ADDENDUM TO THE CONTRACT

MUNICIPAL BUILDING PENTHOUSE SIDING & ROOF REPLACEMENT Contract No. E15-020

ADDENDUM NO.: ONE

MUNI BLDG. PENTHOUSE: EAST ELEVATION:

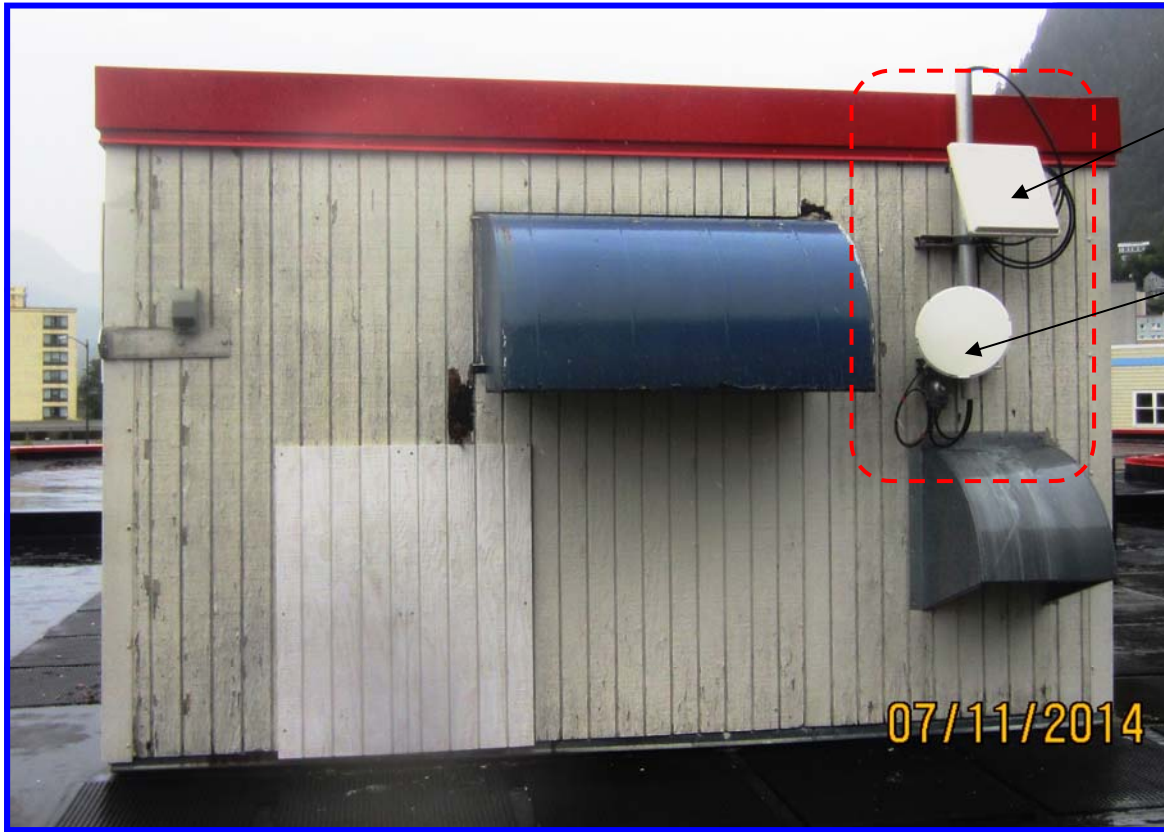
- Item No. 7: SHEET A1 – DEMO, EXTERIOR ELEVATIONS, DEMOLITION NOTES 3. **Delete** "Clean, prime and paint all exposed metal surfaces on (E) mechanical thru-wall hoods. **Insert** "Clean, prime and paint all exposed metal surfaces on two (2) existing painted mechanical thru-wall hoods. Existing galvanized hoods to remain unpainted."
- Item No. 8: COMMUNICATIONS ANTENNA – REFERENCE PHOTOS & INFORMATION. **Add** the attached sheets with photos and clarification information.

Antenna Description	Removal & Reinstall by:		Max. Allowable Outage	Priority Level	Notes:
Tram-CBJ Avalanche relay	Contractor	CBJ IT- Lisa Carson	Up to Two (2) days.	Medium #3	Can be moved up to 4' away
Photo-Right Upper (Square)				Until Snowfall	from penthouse- horizontally
					W/out major loss of signal
Dwntwn Library, Customs Ofc.	Contractor	CBJ IT- Lisa Carson	Two (2) hours max.	Highest #1	Avoid heavy cruise ship days.
		Signal strength testing by IT.			
Docks & Harbors		Certification by Contractor	Submit date and time for	CRITICAL to	Adjustment on library may
Photo-right lower (Round dish)		not required.	Owner review and approval.	Operations.	require a man-lift by Contractor.
